STATE OF DELAWARE
DEPARTMENT OF TRANSPORTATION
800 BAY ROAD
P.O. BOX 778
DOVER, DELAWARE 19903

February 17, 2009

DelDOT Contract Number: 95-090-01; Federal Aid Project Number: IM-N056(27)
I-95 Delaware Turnpike Improvements Project
I-95/SR 1 Interchange/I-95 Turnpike Mainline
Turnpike Mainline from SR 1 to SR 141; I-95/SR 1 Interchange; I-95 Northbound
Widening Extension
New Castle County, Delaware
Environmental Reevaluation [*Change in interchange design*]

January 2009

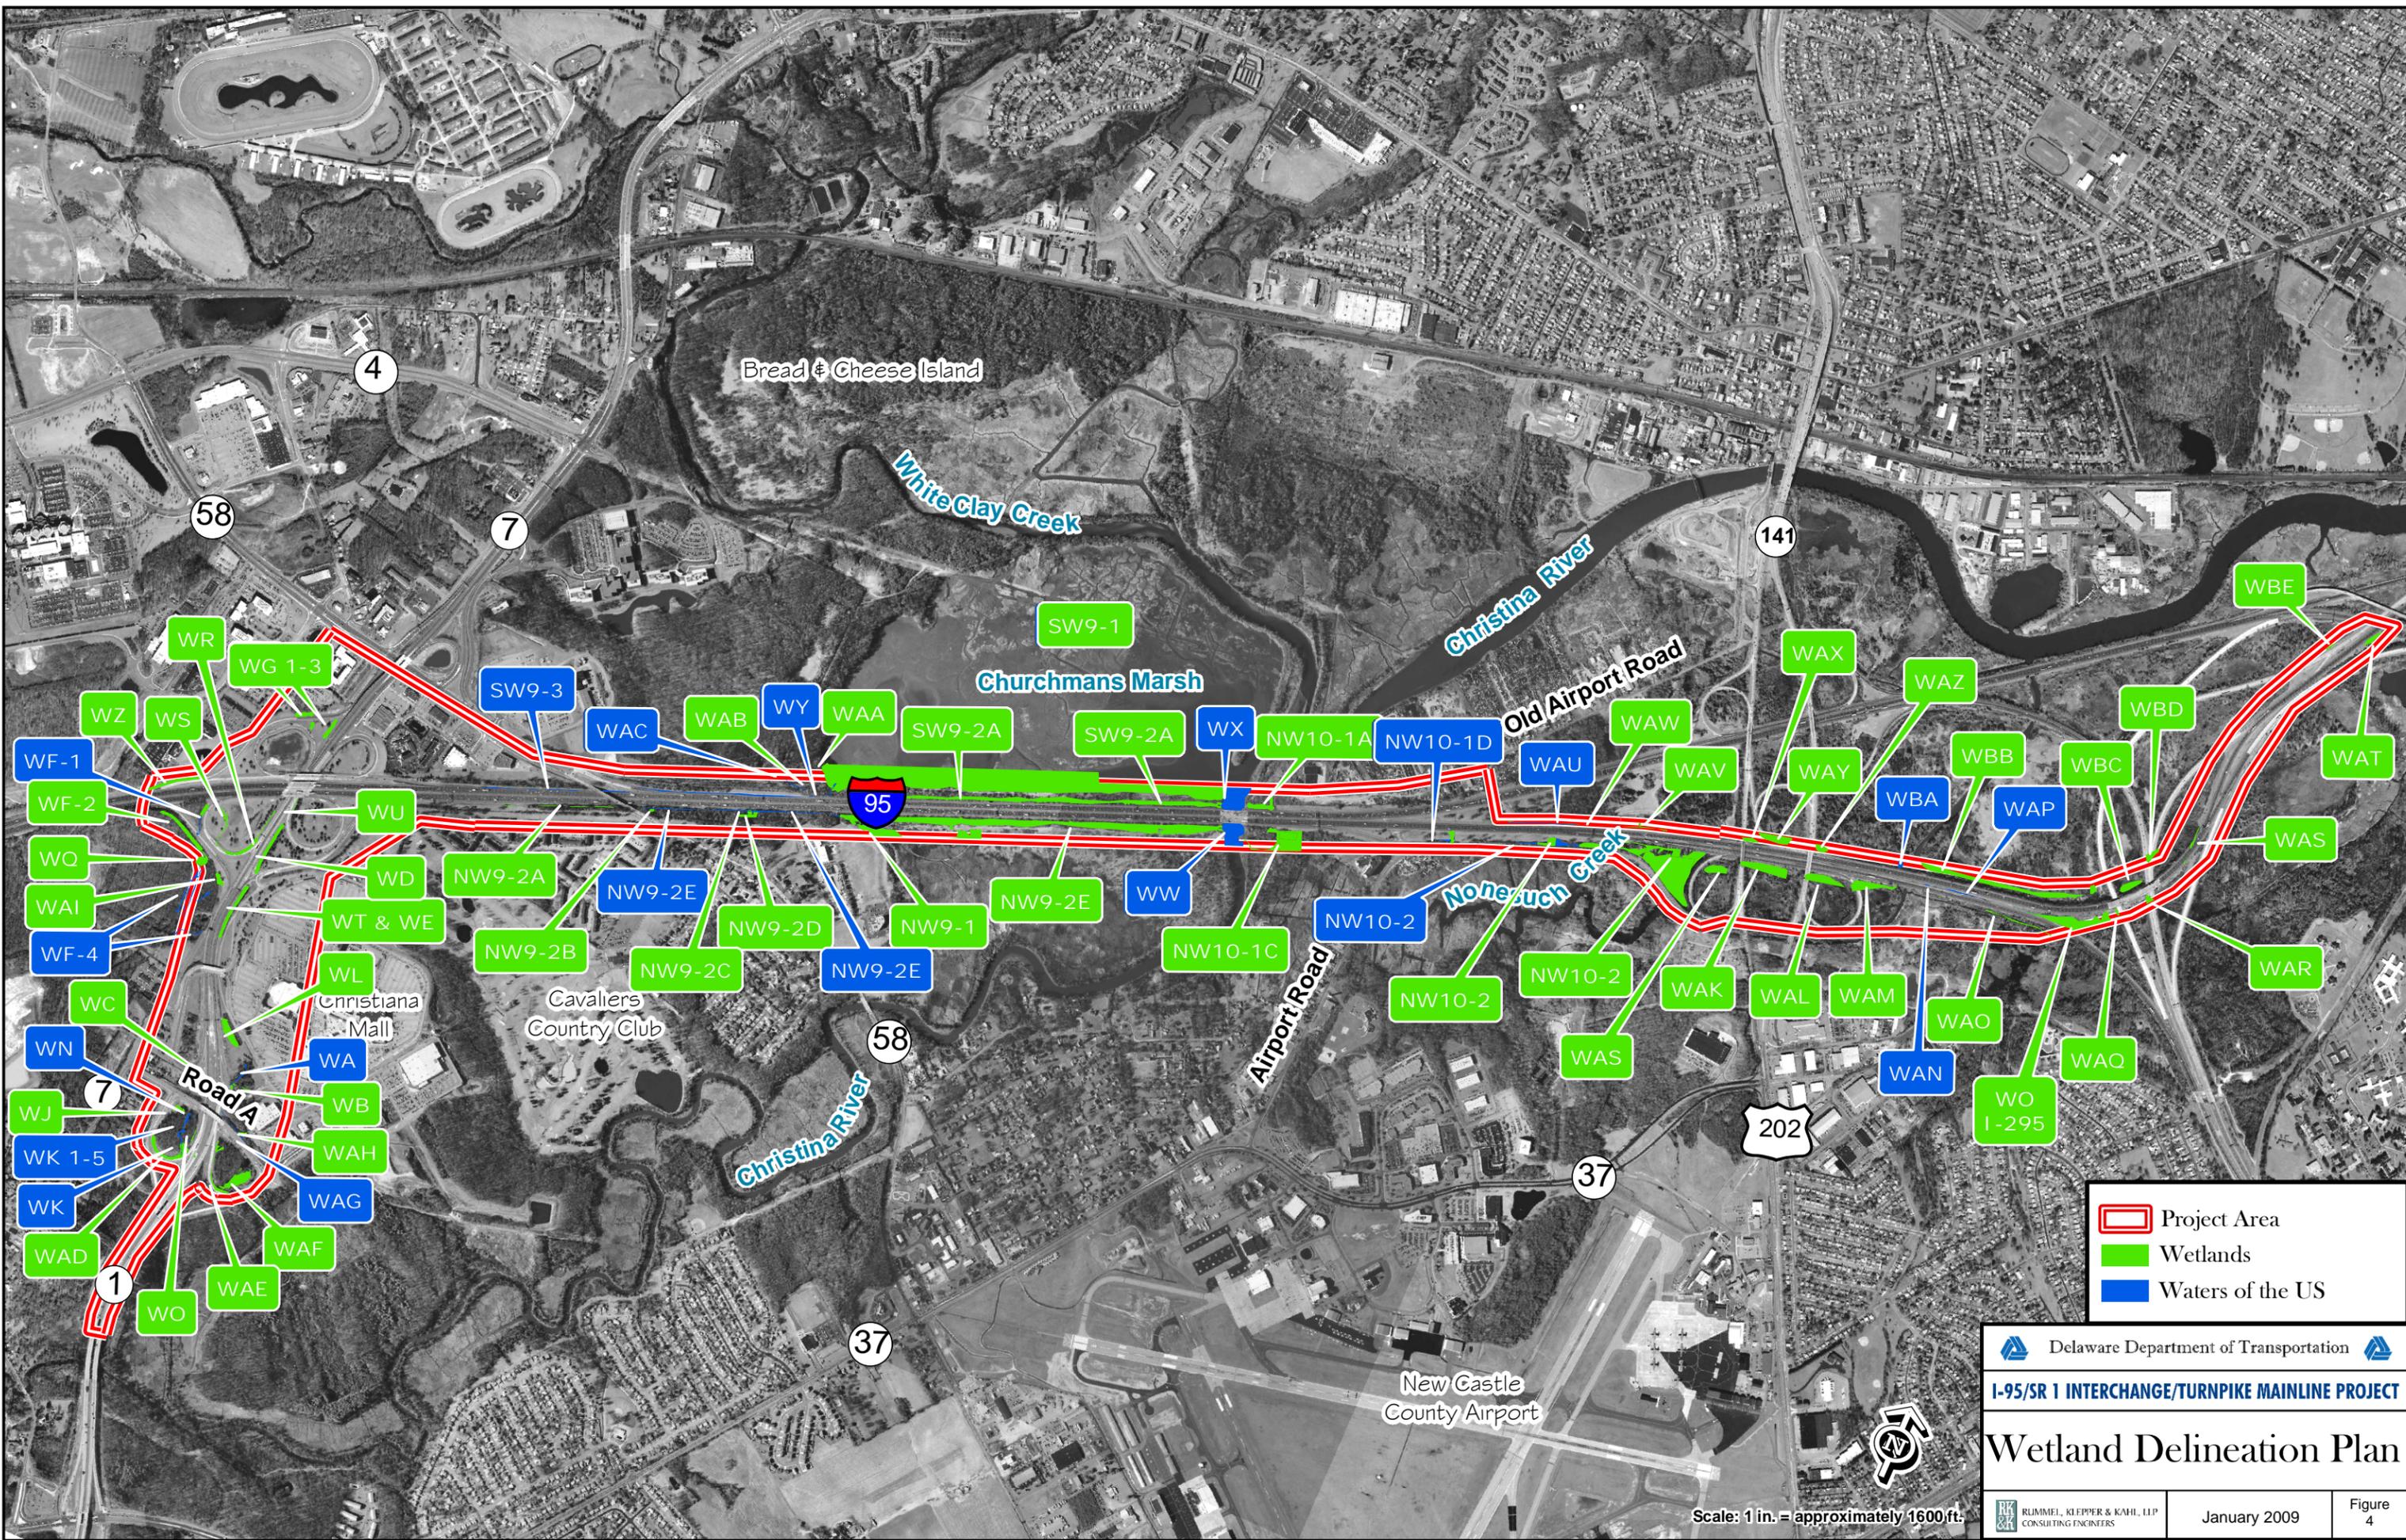
- The existing southeast quadrant loop ramp (from I-95 northbound to SR 7 northbound) has been eliminated and replaced by a semi-directional flyover ramp (identified on **Figure 3** as Ramp C) that extends from the southwest outer ramp from northbound I-95, passes over SR 7 and merges with northbound SR 7.

- The existing northbound lanes of I-95, north of the interchange, are shifted approximately 40 feet to the outside to accommodate Ramp B, which will fly over northbound I-95 and extend as the median lane of I-95.
- Ramp B (SR 1 northbound to I-95 northbound) will split in the vicinity of the southwest quadrant. The left lane will fly over northbound I-95, and become the median lane of the northbound I-95 mainline, as noted above. The right lane of Ramp B (Ramp B1) will extend along the outside of existing northbound I-95 and remain barrier-separated from the northbound I-95 mainline until north of the Churchmans Road bridge, where the lane merges with the existing outside mainline lane.
- The ramp (Ramp R1) to/from the Christiana Mall Road will be relocated approximately 150 feet south of its present location.

- The replacement of the southeast quadrant loop ramp with the directional flyover ramp from I-95 northbound to SR 7 northbound will eliminate the existing weave on northbound I-95, between the entry loop ramp to northbound I-95 from southbound SR 7 and the exit loop ramp from northbound I-95 to northbound SR 7.

- Shifting the I-95 mainline to the outside and bringing the split Ramp B (SR 1 northbound to I-95 northbound) into I-95 as the median lane of I-95 allows motorists from SR 1 destined for Wilmington to avoid having to weave across four lanes of I-95 within a distance of approximately four miles.

- The relocation of the Ramp R1 bridge approximately 150 feet to the south will allow for a lower profile for the ramp bridge and the reconstructed Christiana Mall Road, thus reducing the impact to the mall parking lot and eliminating a proposed retaining wall. Shoulder reductions in some areas have been reduced from 16/24 feet to 12 feet to accommodate the changes and avoid additional property acquisition from the Mall.

See **Figure 3** for locations of Ponds A-F.

Delaware Department of Transportation
I-95/SR 1 INTERCHANGE/TURNDPIKE MAINLINE PROJECT
Wetland Delineation Plan

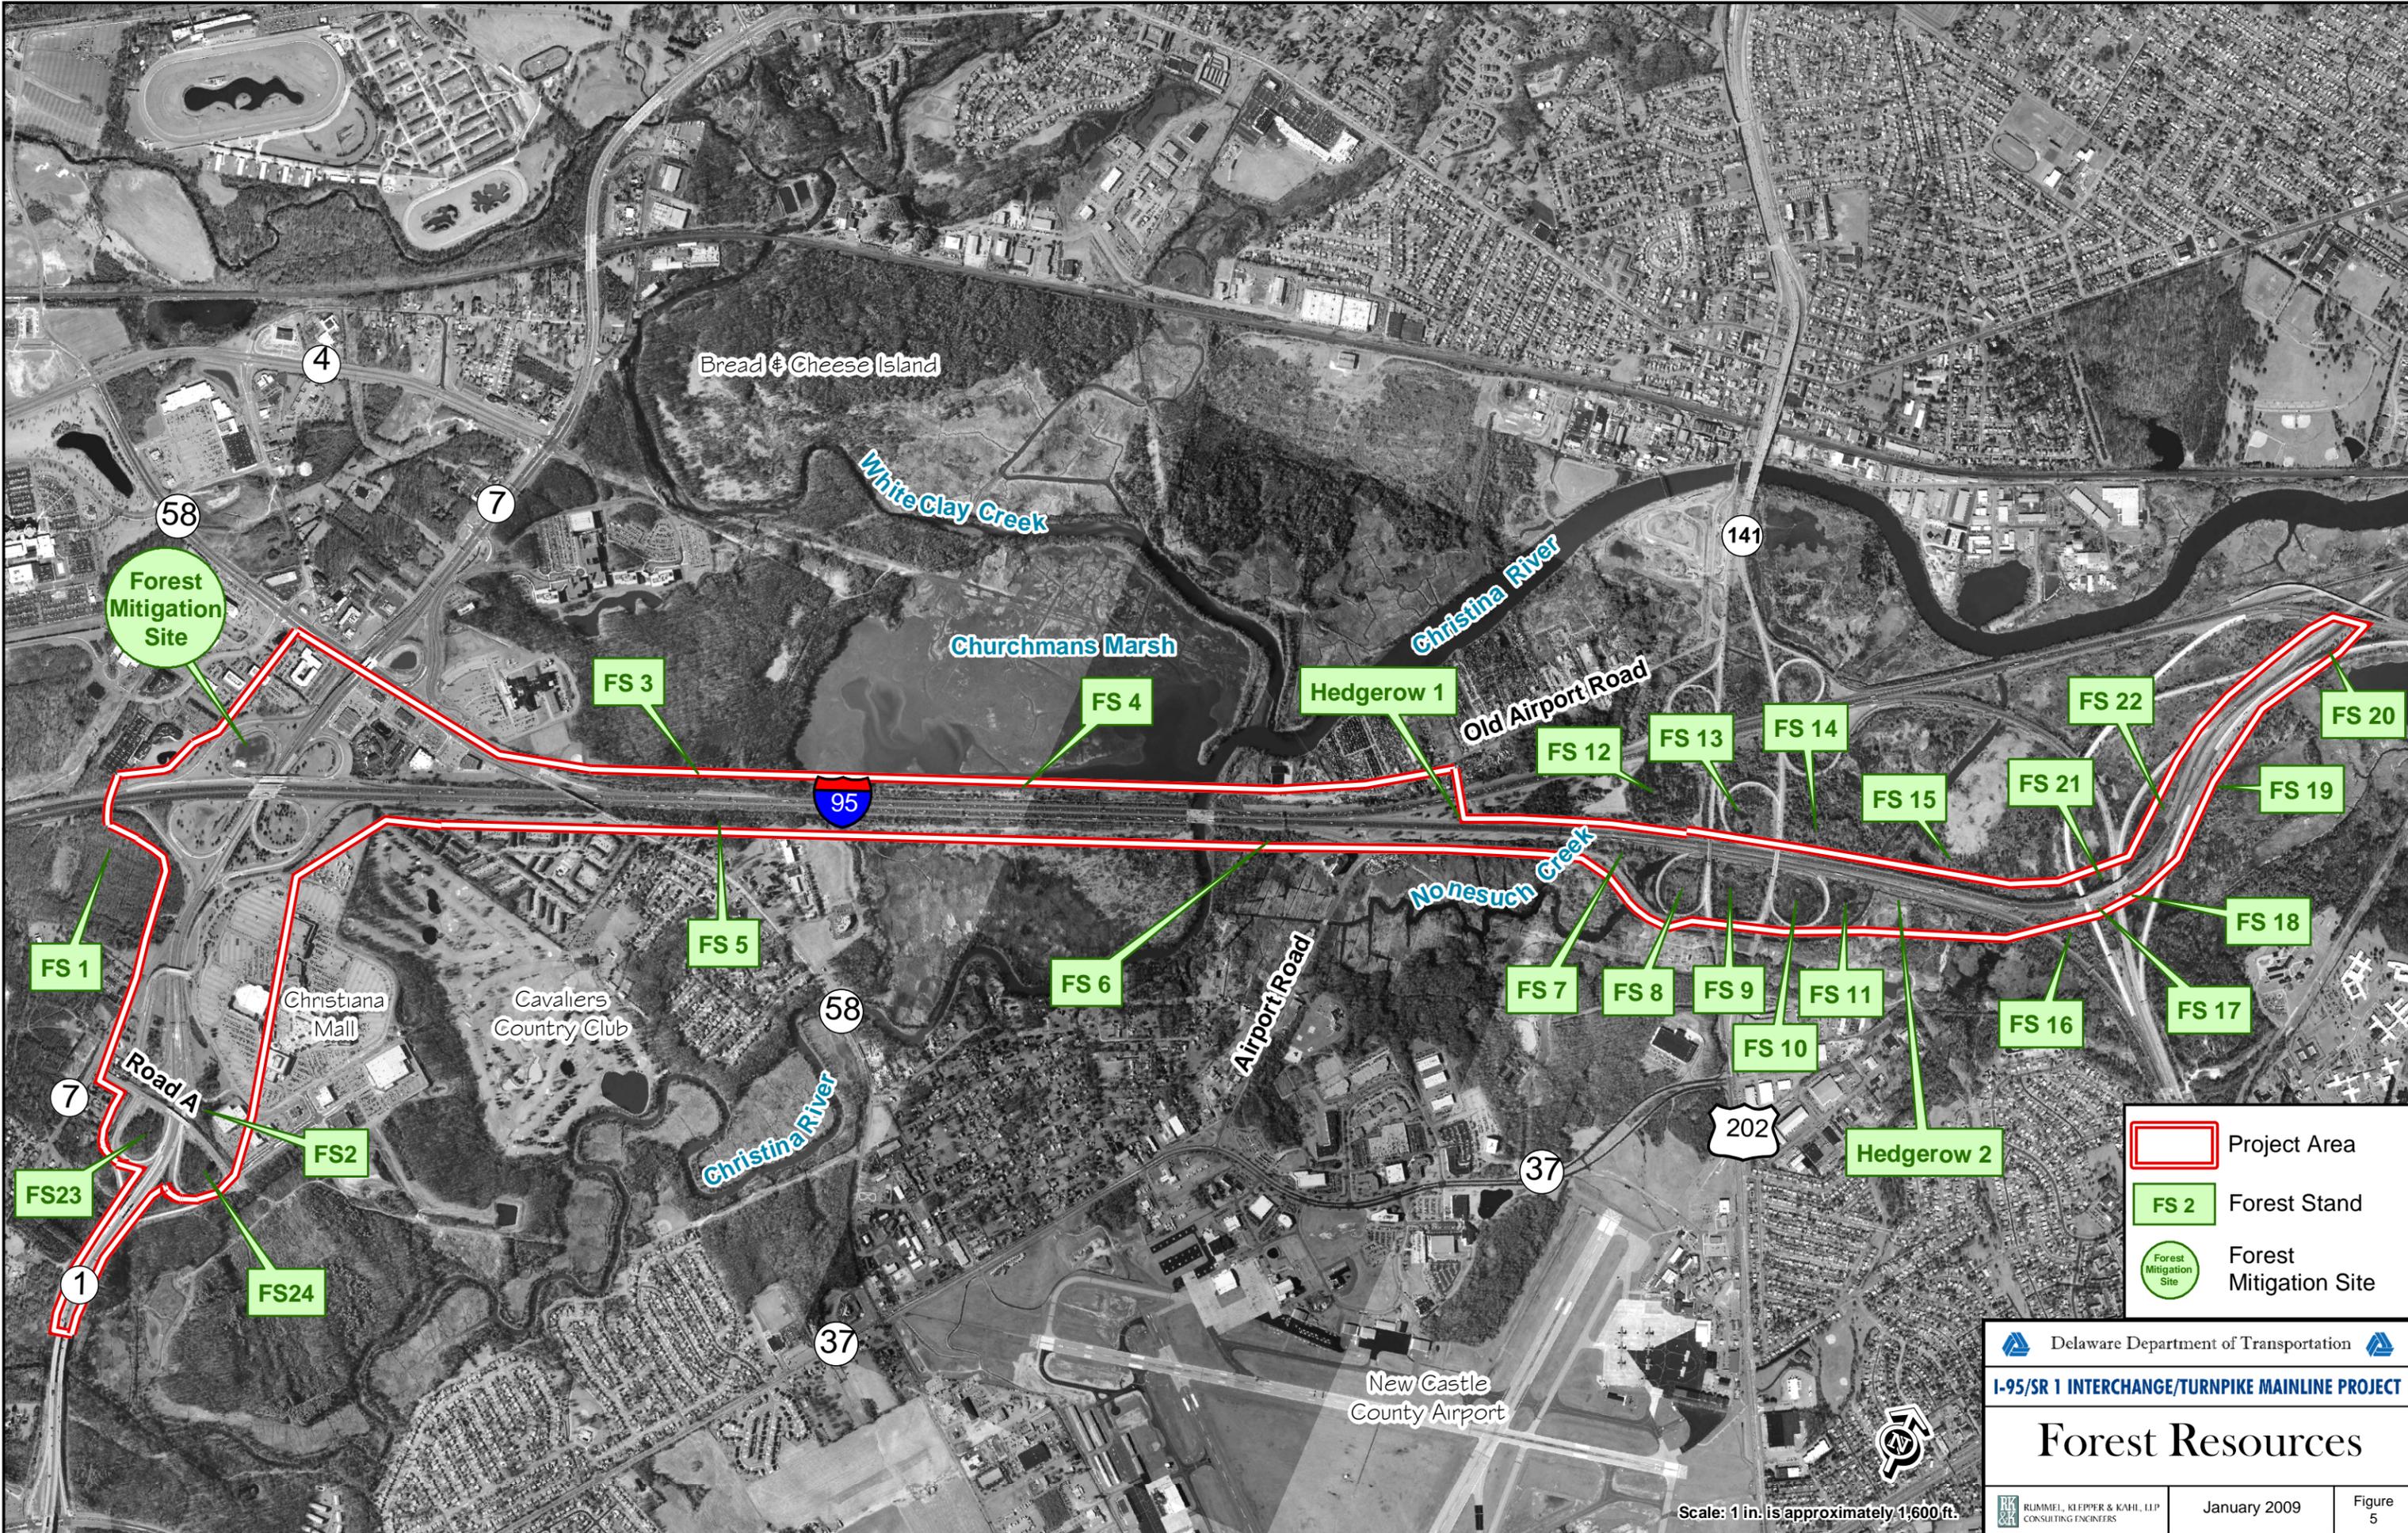
There are no newly-identified streams or wetlands within the interchange project area. **Figure 4** shows the approximate locations of all Waters of the US, including wetlands, identified in the I-95/SR 1 interchange project area. Following the 2006 reevaluation, where the revised/extended design of the Turnpike mainline *reduced* the number of acres of impacts from 2.17 acres to 2.02 acres, the FHWA received an ACOE permit to impact a total of 2.08 acres of wetlands and other Waters of the US. There will be an additional 0.26-acre increase in impacts to Waters of the US due to the modifications of ramps and bridges in the current design. **Table 3** highlights the total impacts to Waters of the US, while **Table 4** details the changes due to the current design.

The modifications to Ramp B will result in an increase of 0.10 acre of non-tidal wetland impacts (wetlands WD, NW9-2B, NW9-2C and NW9-2D as shown on *Figure 4*). The change in design from the loop ramp in the southeast quadrant to a semi-directional flyover ramp will result in no change to wetland impacts. The relocation of the Ramp R1 bridge approximately 150 feet to the south will result in an increase of 0.16 acres of impacts to non-tidal wetlands (wetland WL on *Figure 4*). The current design would change the total impacts to wetlands and other Waters of the US from the January 2006 impact of 2.02 acres to 2.28 acres. Wetlands would account for 1.02 acres, and waters (streams, channels and ditches) would account for the remaining 1.31 acres.

Forest Resources

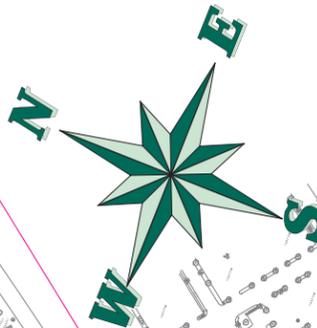
There will be an additional 0.35 acres of forest impact due to the design modification. Forest Stand FS 5 (shown on **Figure 5**) will be impacted by Ramp B1 as it merges with I-95 along the outside of the southbound roadway. This will increase the total forest impacts to 4.35 acres. An area of reforestation is available following the removal of the loop ramp in the southwestern quadrant (southbound SR 7 to southbound I-95) that will accommodate a total of 4.97 acres of new forest, after some soil modification. An additional 0.40 acres is still available on the Cathcart mitigation site.
